Flight Procedures Cover Page	Task Action: FLIGHT CHECK	Task Type: IAP	Estimated Chart Date: 05/19/2022	APWS Task ID: B257F081F43B4F638E59BE973808D457	APWS Project ID: EEB757C1A2274DE5A328AFC1972167B9
Procedure: RNAV (RNP) X RWY 28L AMDT 1		Enroute: NO	Specialist: Lindholm, Scott		Agreement Number:
Airport ID: KBOI			Airport City: BOISE		State: ID
Facility ID:	Facility Type:	Flight Inspection Remark Type: New FC Slot			
<p>Procedure Comments:</p> <p>FULL AMENDMENT FOR STAR CONNECTIVITY.</p> <p>AMENDMENT COMPLETED USING ACTIVE AIRPORT DATA.</p> <p>CONTACT DON LANIER (AJV-A431) 405-954-8242</p> <p>WAIVERS (1): CANCELLATION OF WAIVER NO LONGER NEEDED TO PUBLISH 0.15 RNP MINIMA WITHOUT 0.30 RNP MINIMA IAW 8260.19I para 8-6-11.I NOTE 1.</p>

Boise, ID
Boise Air Terminal/Gowen Fld (KBOI)
RNAV (RNP) X RWY 28L

KBOI
BOISE AIR TRML/GOWEN FLD
BOISE, ID
RNAV (RNP) X RWY 28L, AMDT 1
JIMMI C-I-H
1:500,000

OLD

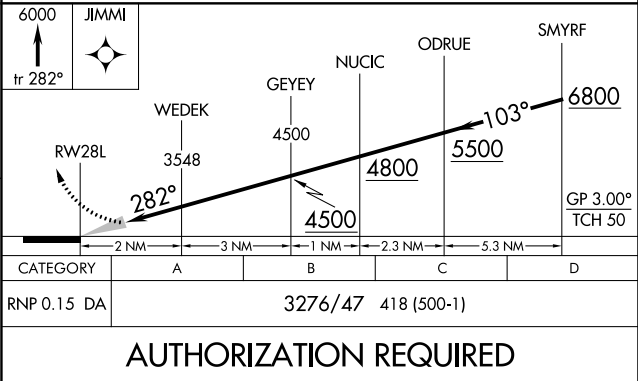
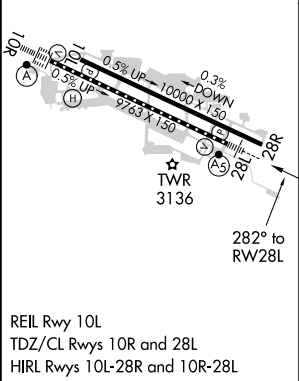
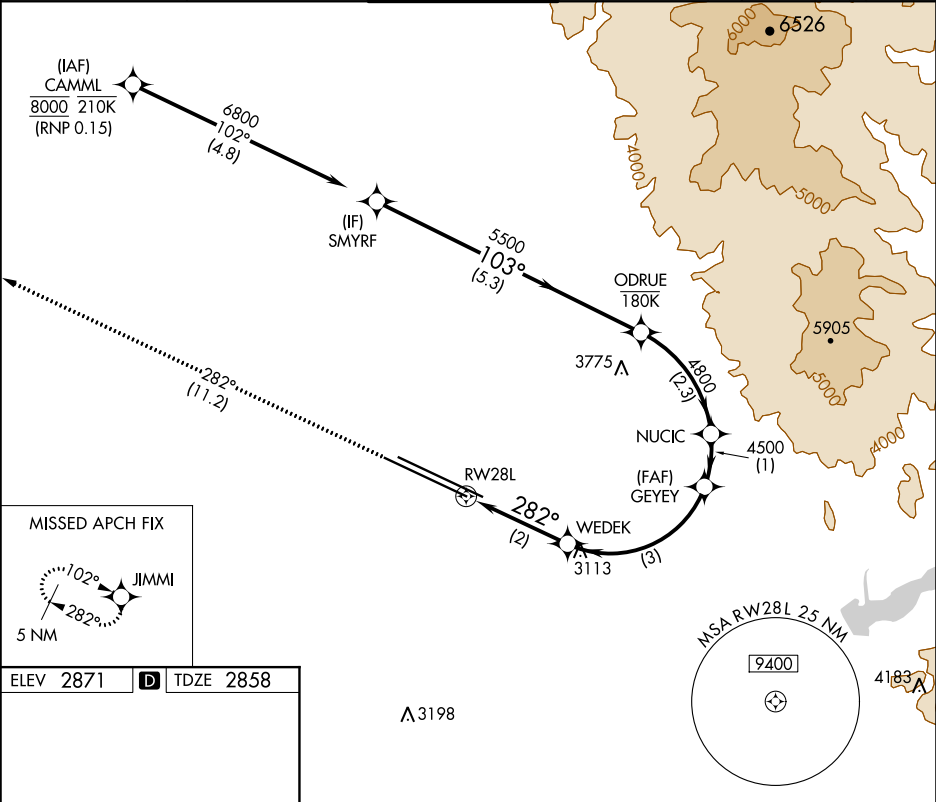
THIS WAIVER IS CANCELLED EFFECTIVE CONCURRENT
WITH PUBLICATION RNAV (RNP) X RWY 28L AMDT 1.
WAIVER NO LONGER REQUIRED, SEE 8260.19I PARA
8-6-11.I.NOTE 1.

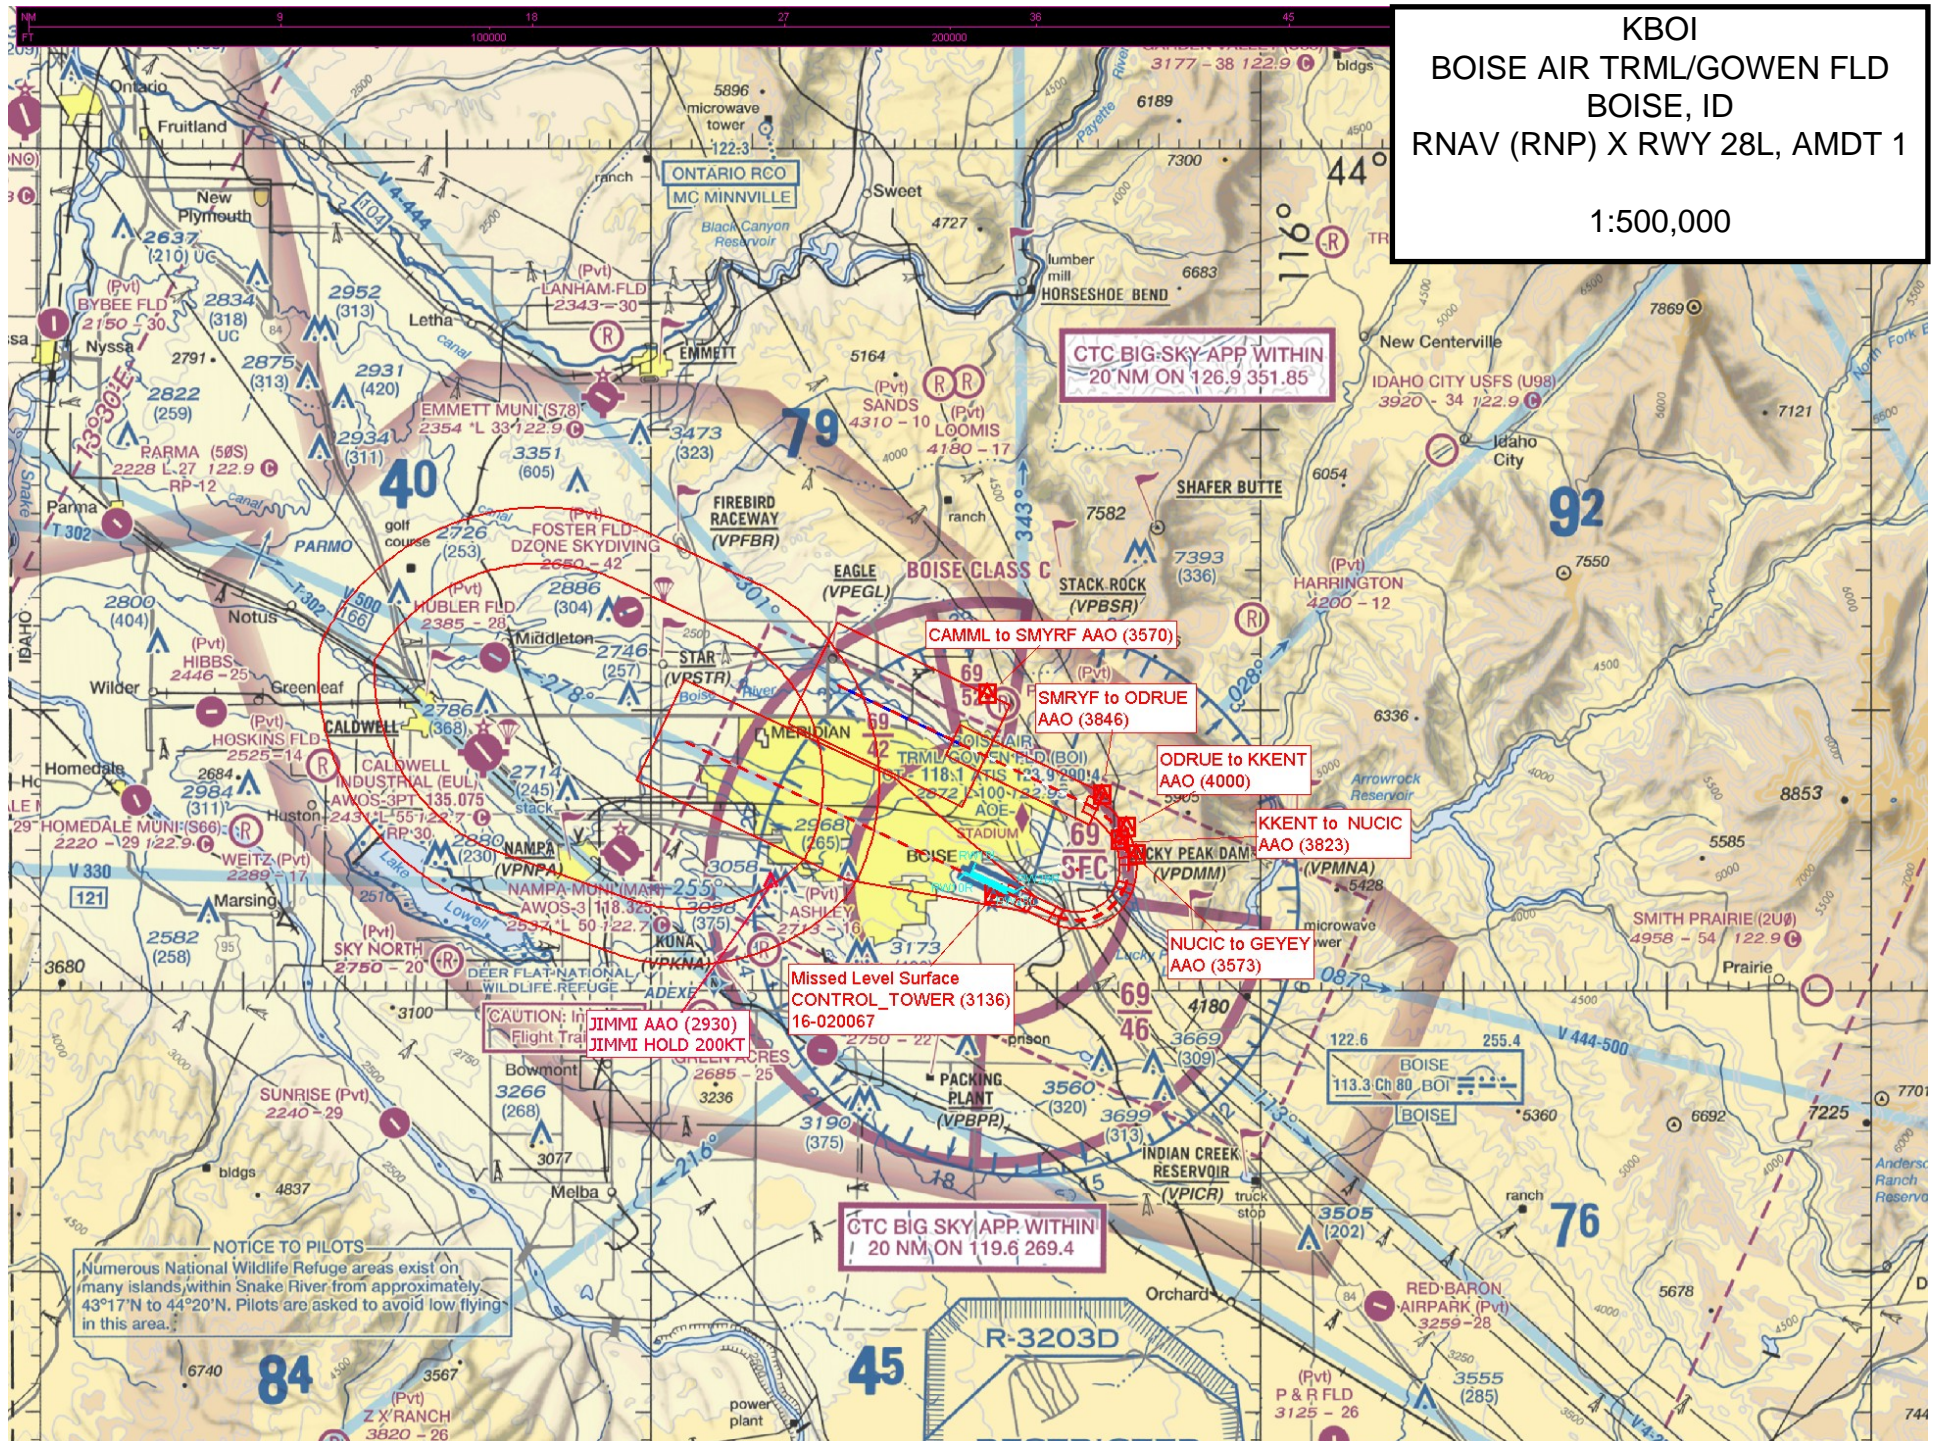
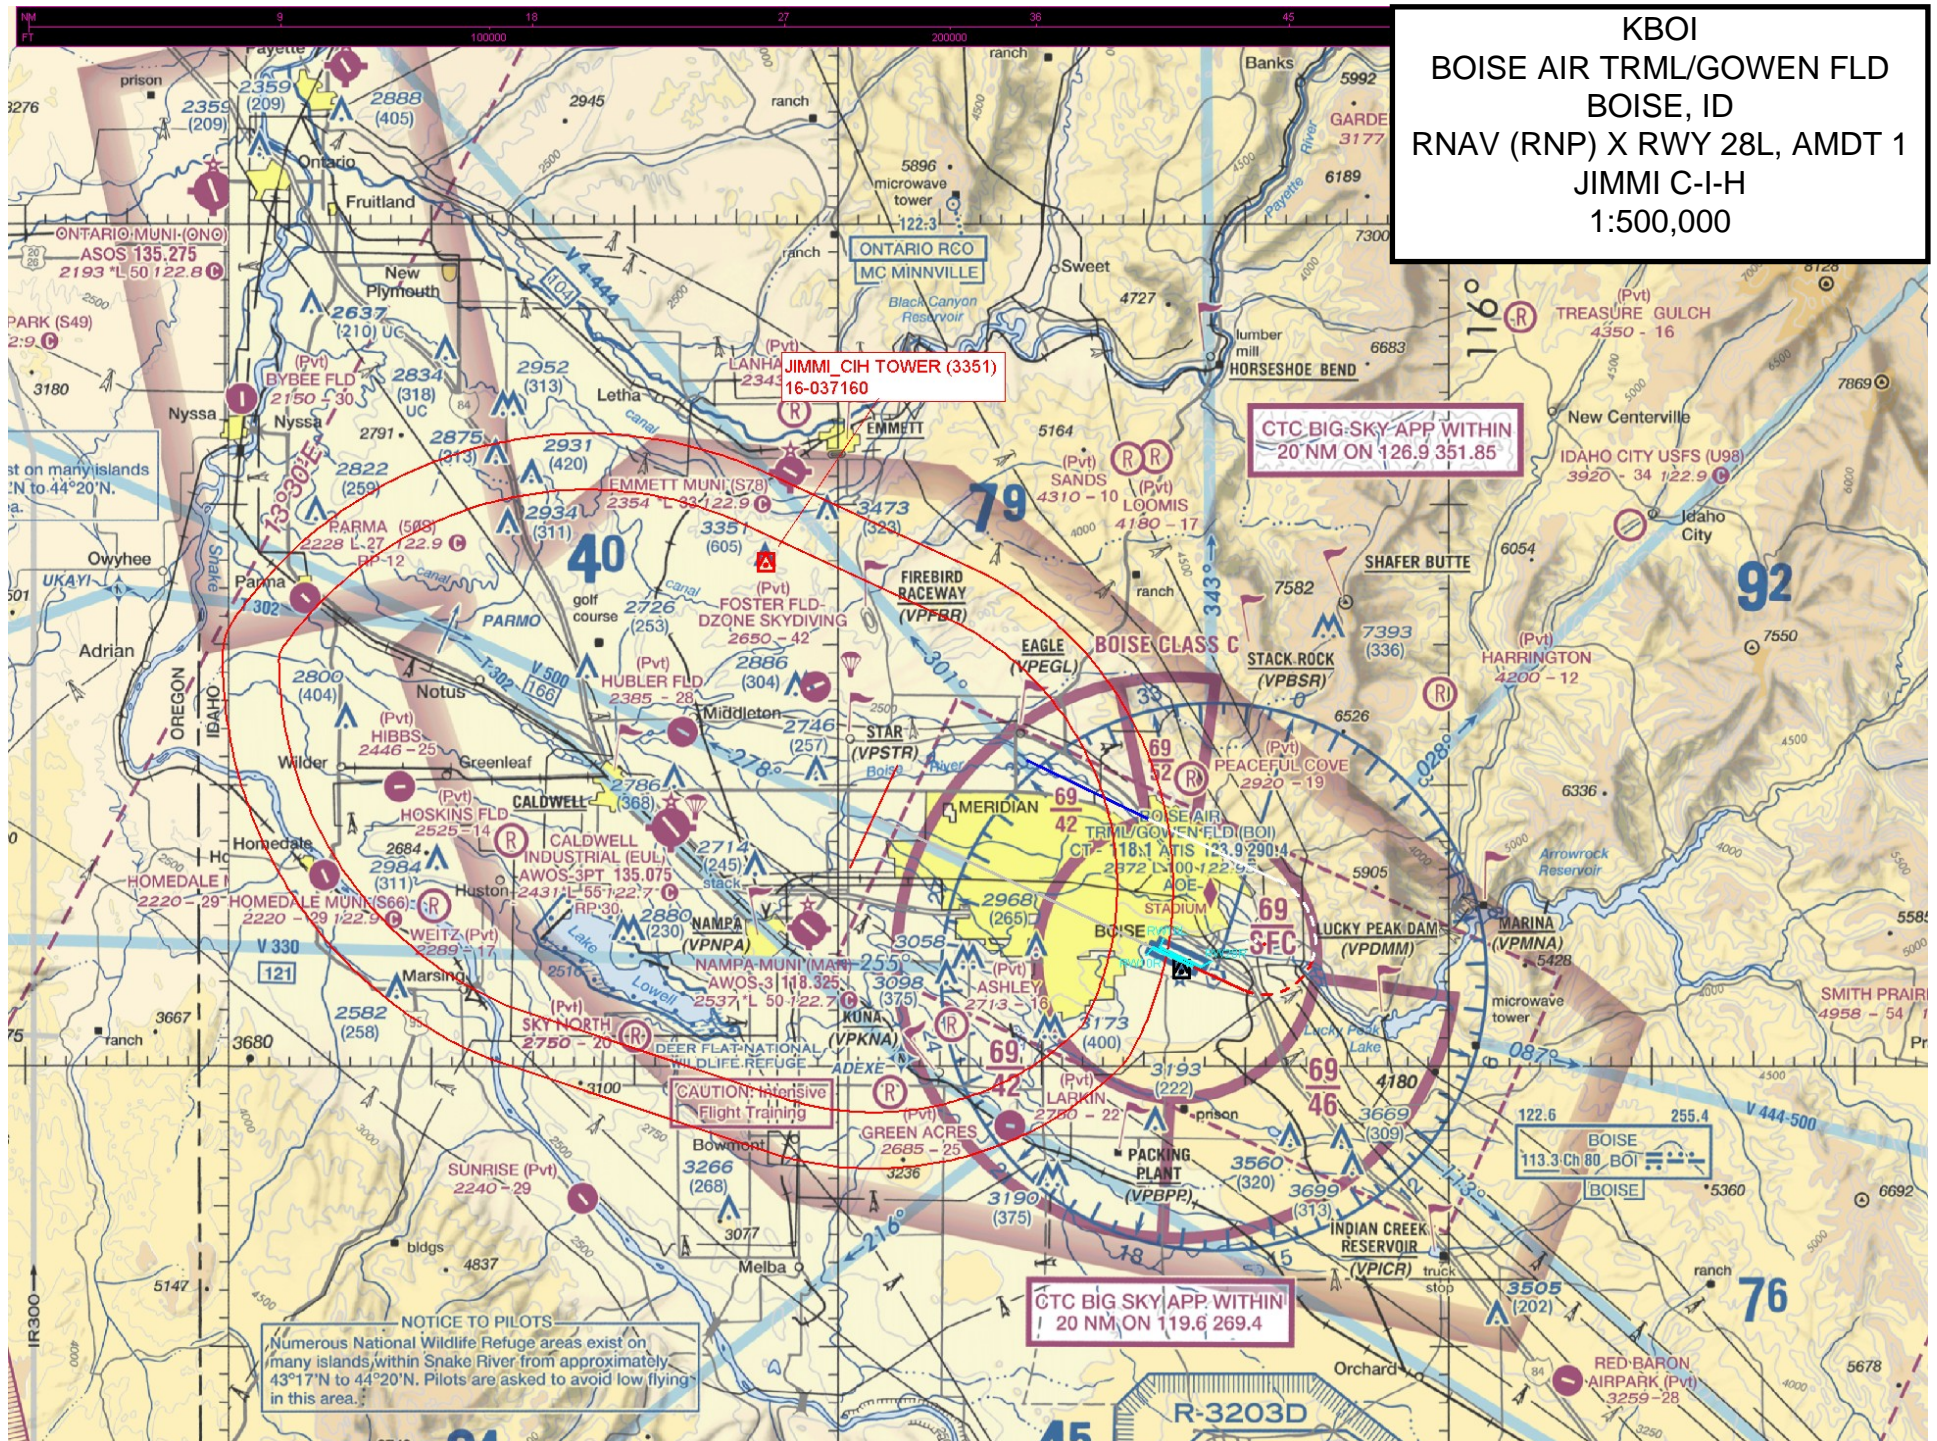
RNP	Required Navigation Performance
RNAV (RNP) Z RWY 28L	<ul style="list-style-type: none">- The missed approach holding fix at JIMMI WP would be relocated approximately (~) 1.45 NM to the northwest.- The following changes were amended for the September 9, 2020, chart cycle and have previously been processed:<ul style="list-style-type: none">o Relocated NEWKU WP ~0.5 NM west.o Relocated DIKAC WP ~3.26 NM southwest.- Altitude would increase at DIKAC from 6,000 feet (ft.) mean sea level (MSL) to at 7,000 ft. MSL.- Altitude would increase at CIPSA from at or above (AOA) 5,000 ft. MSL to AOA 5,300 ft. MSL.- The following changes would apply when the amended 15 procedures are published:<ul style="list-style-type: none">o Missed Approach holding fix at JIMMI WP would be relocated ~1.45 NM northwest.o All other flight tracks and altitudes would remain unchanged.
RNAV (RNP) X RWY 28L	<ul style="list-style-type: none">- JIMMI WP would be relocated ~1.45 NM to the northwest with an increase in altitude from 5,000 ft. MSL to AOA 6,000 ft. MSL.- ODRUE WP would be relocated ~0.2 NM to the northwest, but retain the same altitude restriction of AOA 5,500 ft. MSL.- A step-down fix (SDF) would be added between ODRUE WP and NUCIC WP, with a crossing altitude of AOA 4,900 ft. MSL.- All other flight tracks and altitudes remain unchanged.
